DS-K1T671 Series MinMoe Terminal

Release Notes (2023-10-19)

Device Model: DS-K1T671M/MF DS-K1T671TMW/TMFW	Firmware Version	ARM: ACS_671_AI3_EN_STD_V3.7.0_build231019 ACS_671_AI3_EN_NEU_V3.7.0_build231019
	Software Version	HikCentral AC: https://www.hikvision.com/en/support/download/software/hikcentral-access-control-v2-1/
Naming Rule: M for M1 card, W for WIFI, F for fingerprint

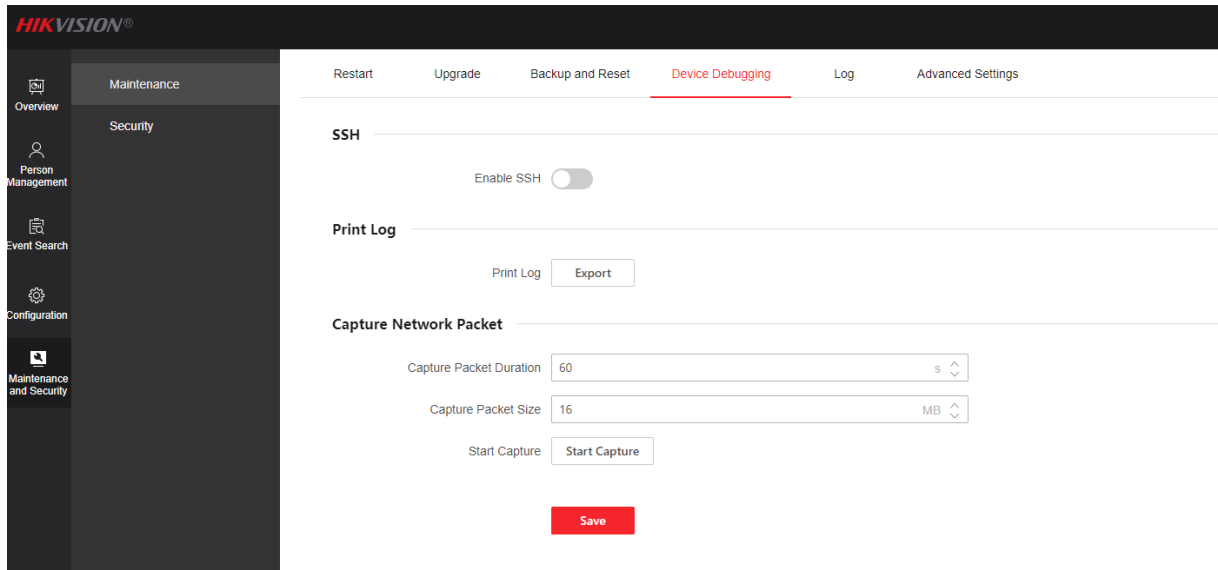
1. Add security issues and secure email (overseas) password retrieval function.

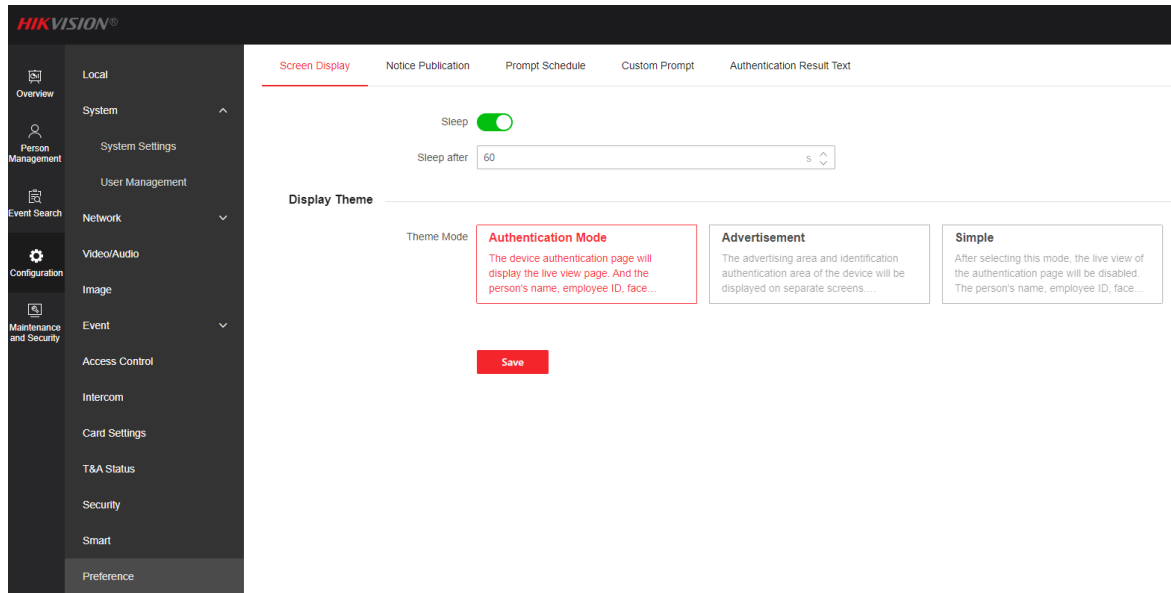
2. Add web network packet capture function.

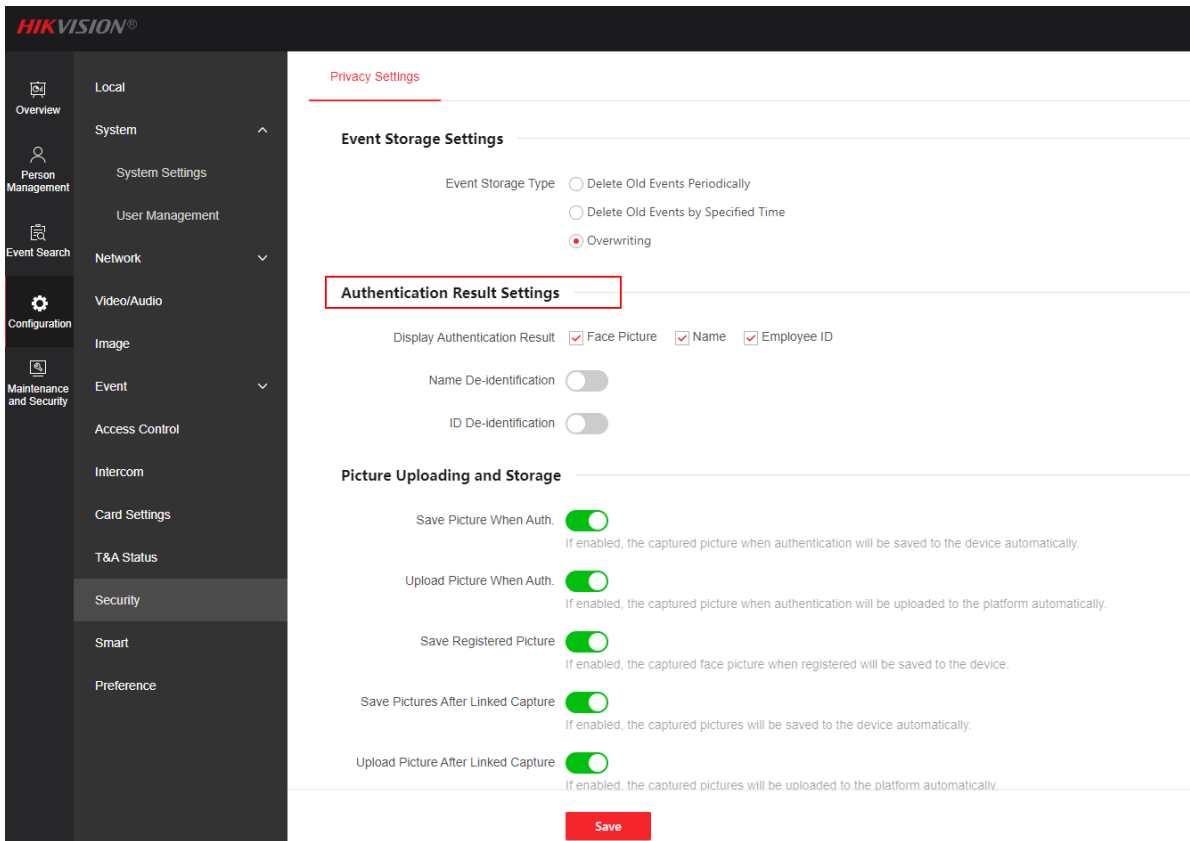
3、 Add advertising mode and concise mode to the device display interface.

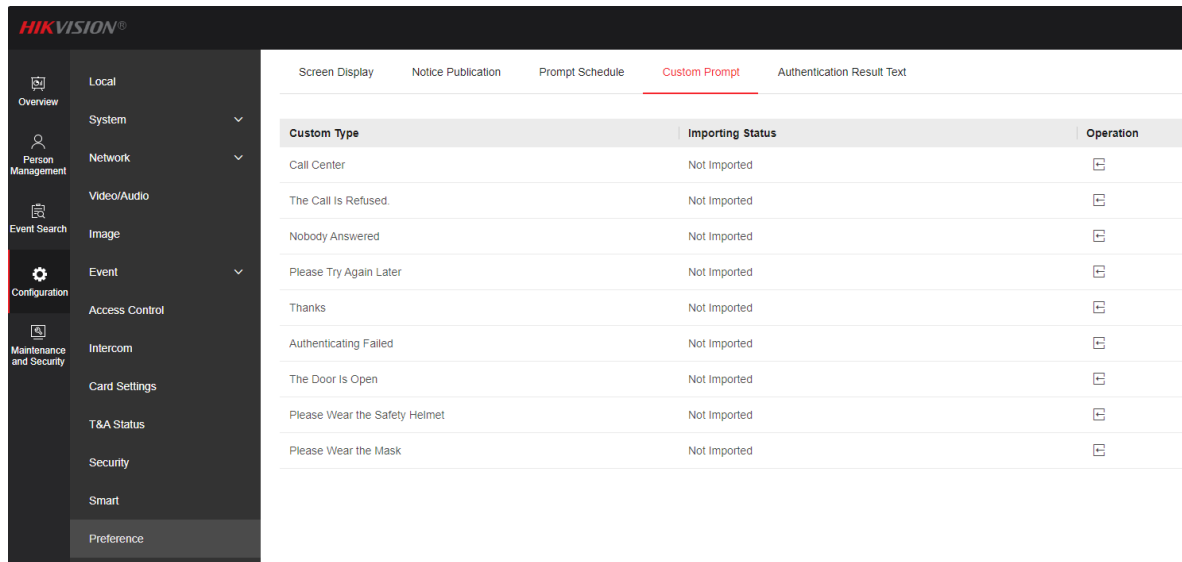
4、 Support UI authentication result desensitization display of employee ID and name. After turning on the function, the displayed content will hide true information.

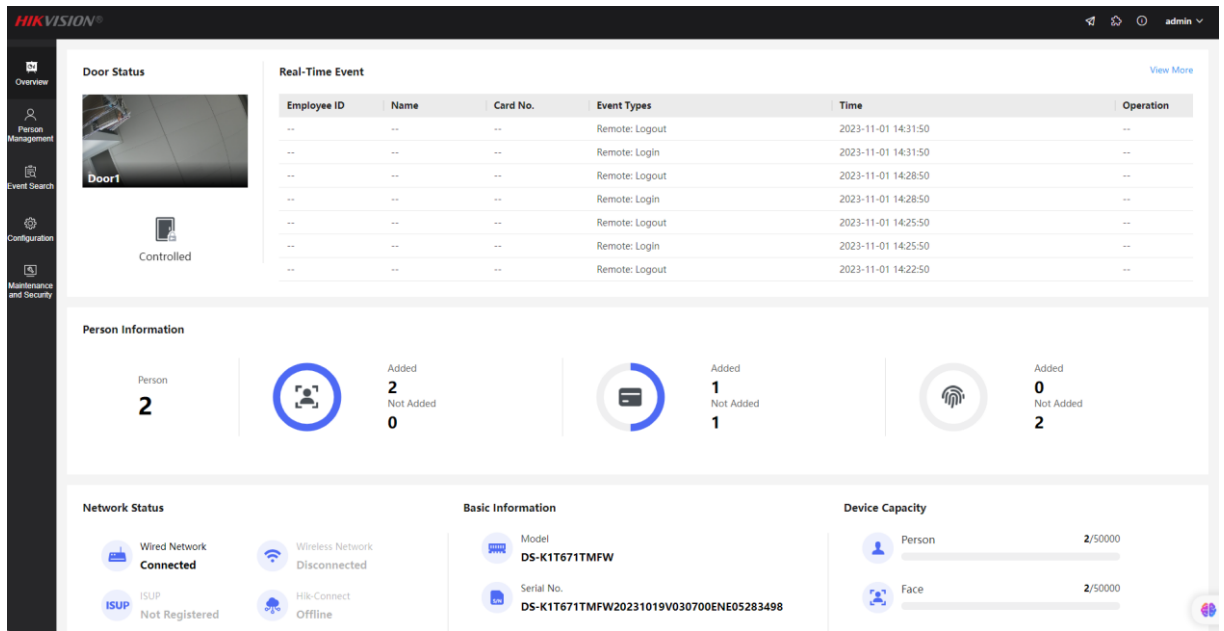
5、 Support for custom prompt tones. The Audio format should be wav. Each Audio size should be less than 512KB.

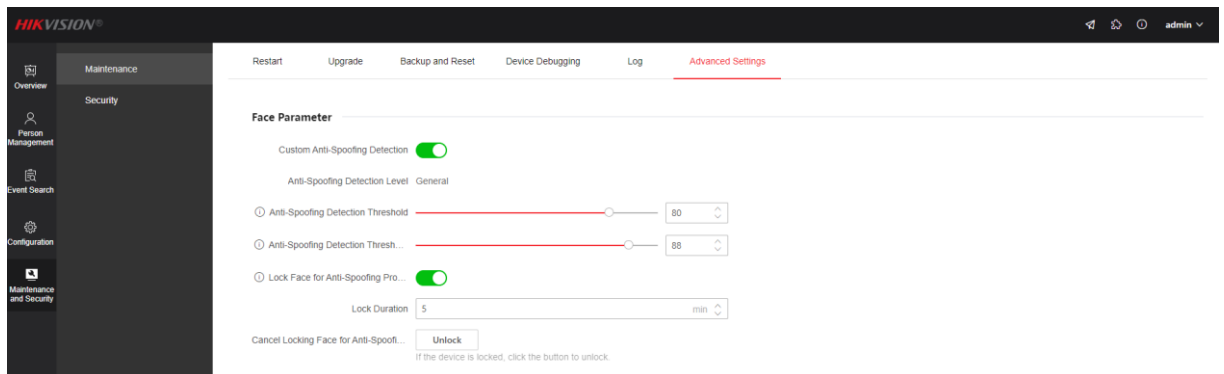
1、 Improve the display effect of the interface.

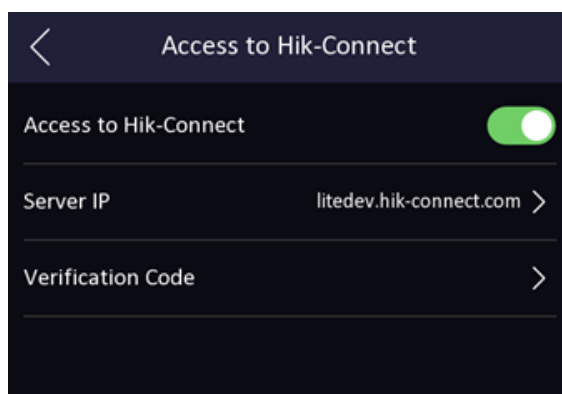
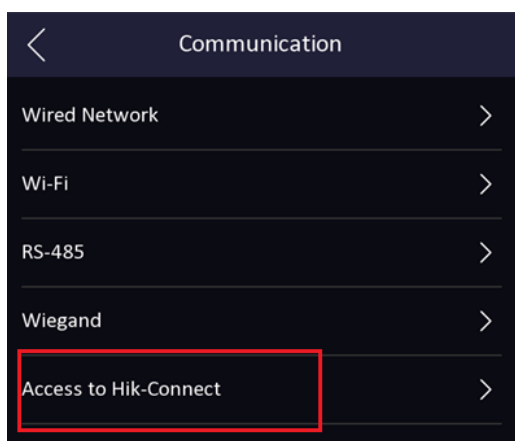
1. Add Hik-Connect menu in device UI Menu → Comm. The function is disabled in default.

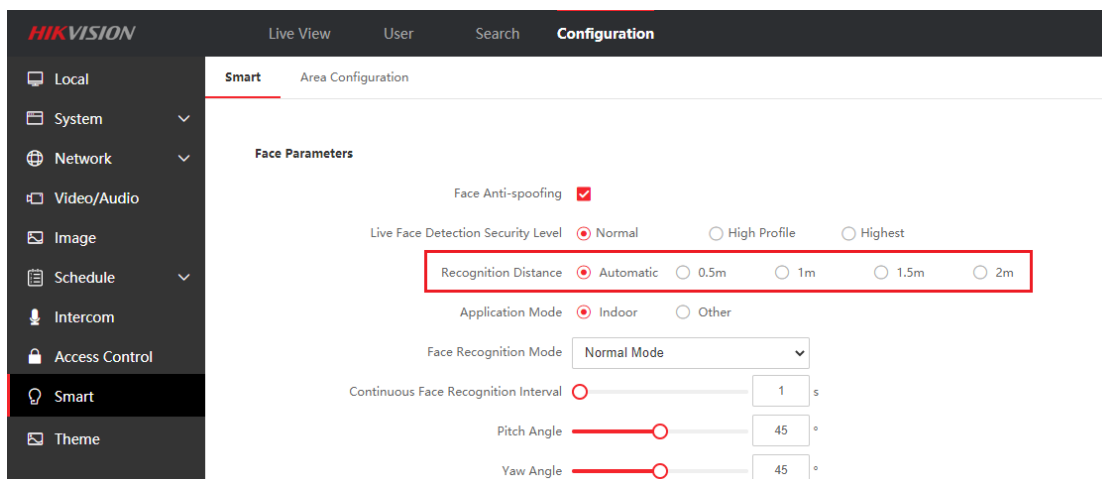
1. Optimize the wake-up distance of the device screen through the face, and the wake-up distance is consistent with the recognition distance

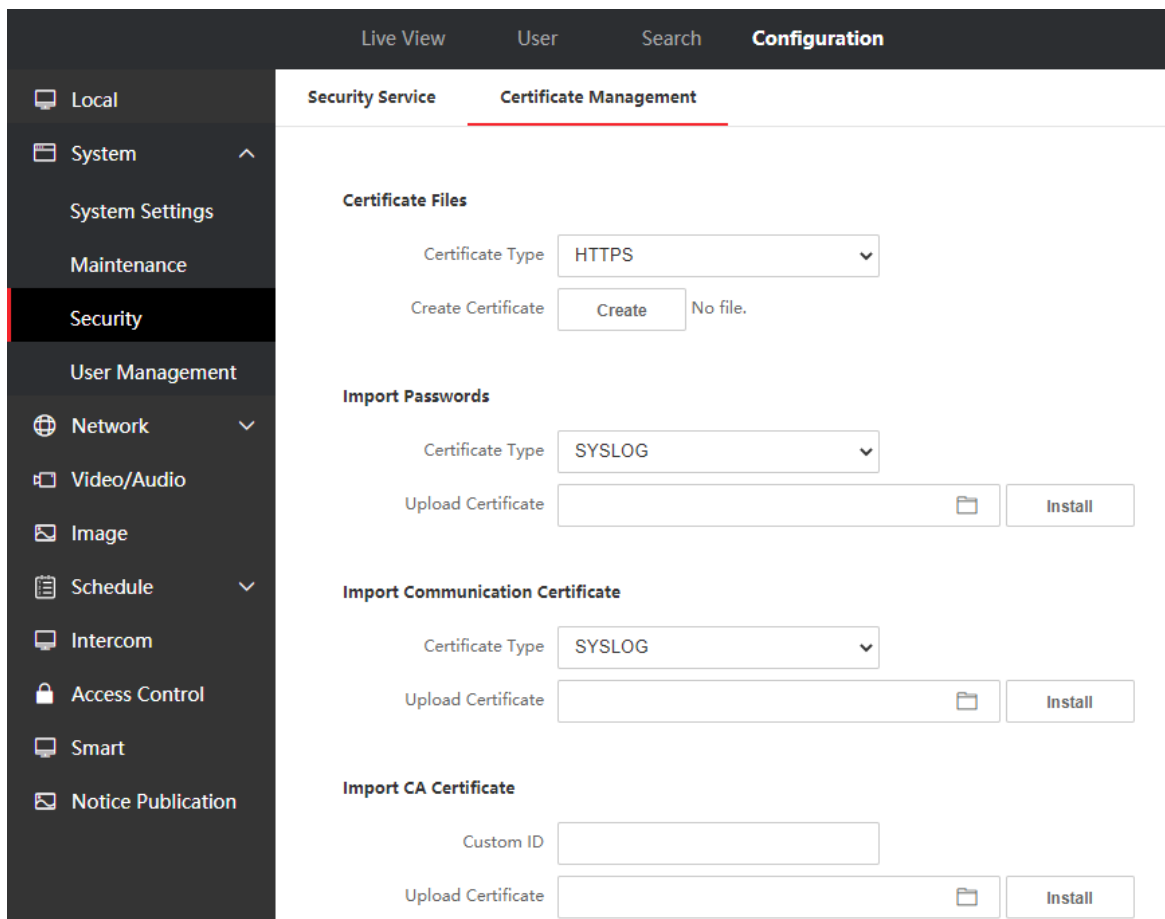
1. Support https feature

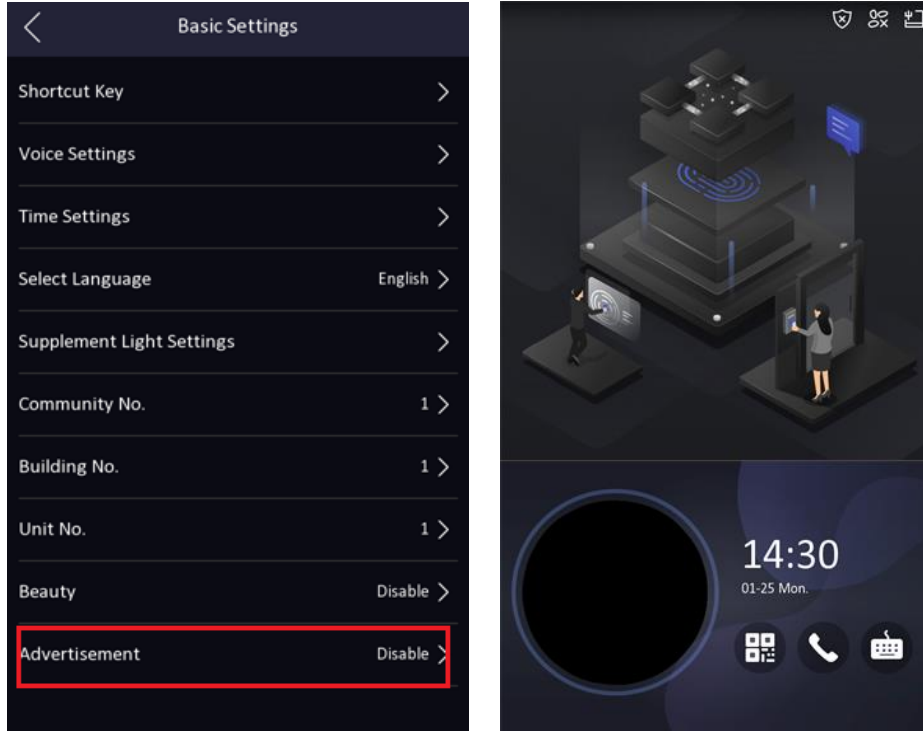
4. Add advertisement mode, after enable, the wallpaper will be fixed to be displayed on the top of main interface.

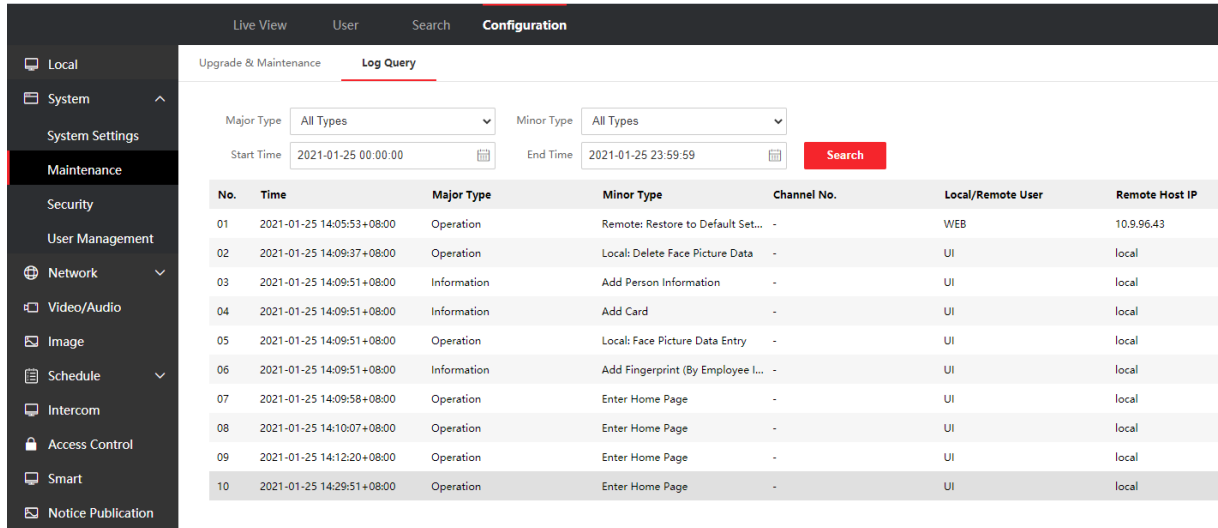
5. Add device operation log query function

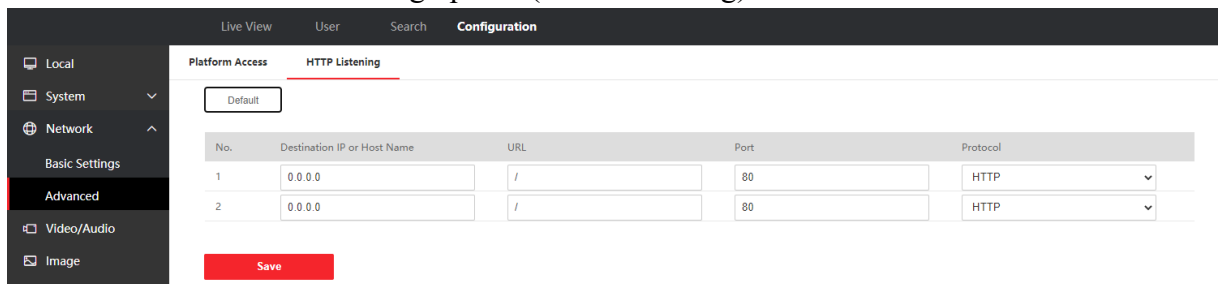
6. Add ISAPI event monitoring upload (HTTP listening) function

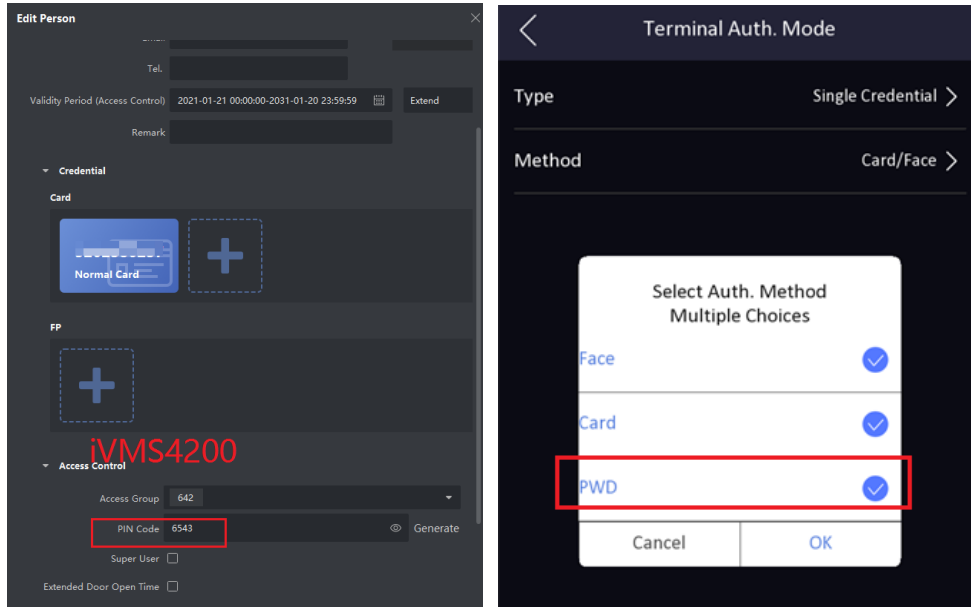
7. Support PIN code to open the door (disabled in default)

Note: PIN code should be configured from software, iVMS4200 already support, HikCentral Pro will support PIN code configuration in V2.1 expected to be released in June

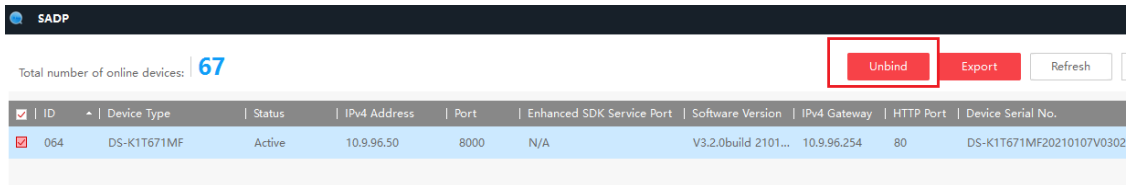
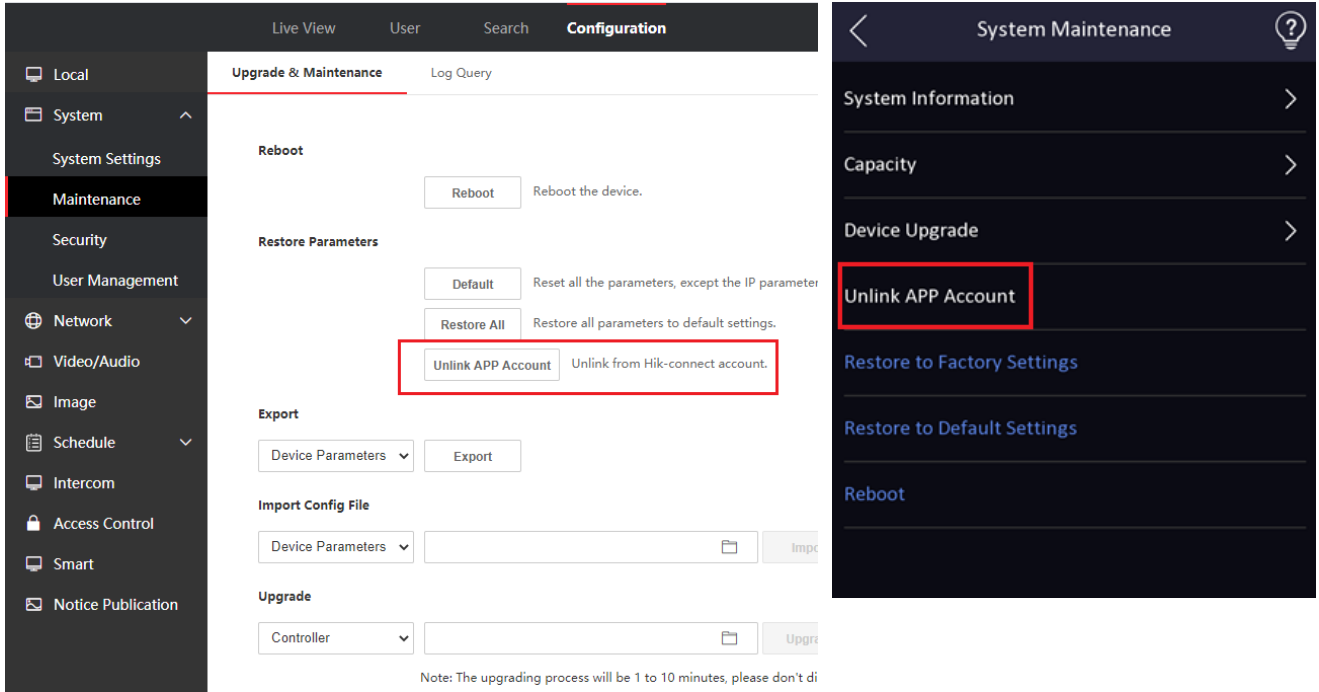
8. Support unbind device with hik-connect account on SADP tool, local UI and web interface

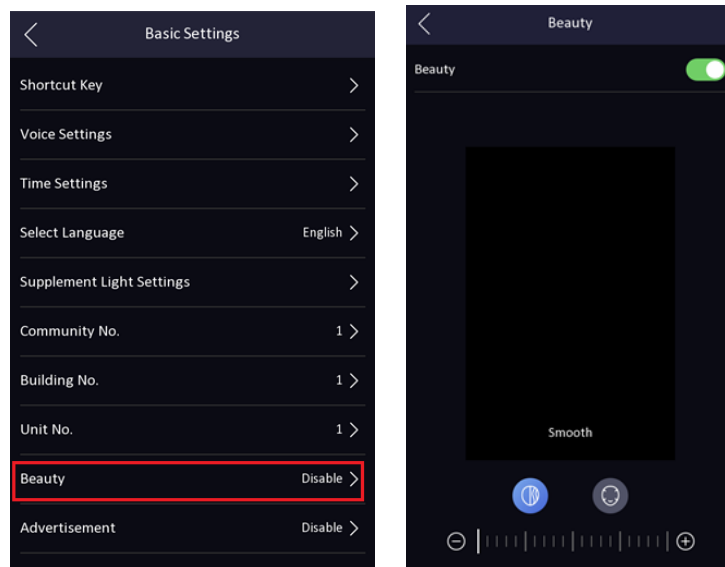
9. Add beauty function to adjust smooth and whiten parameter.

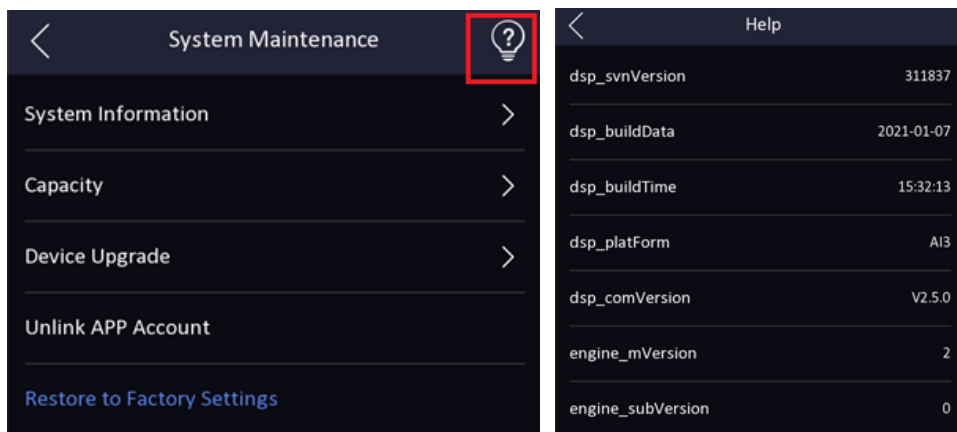
10. Add help interface to check system module version for technical support (long press for 3s).
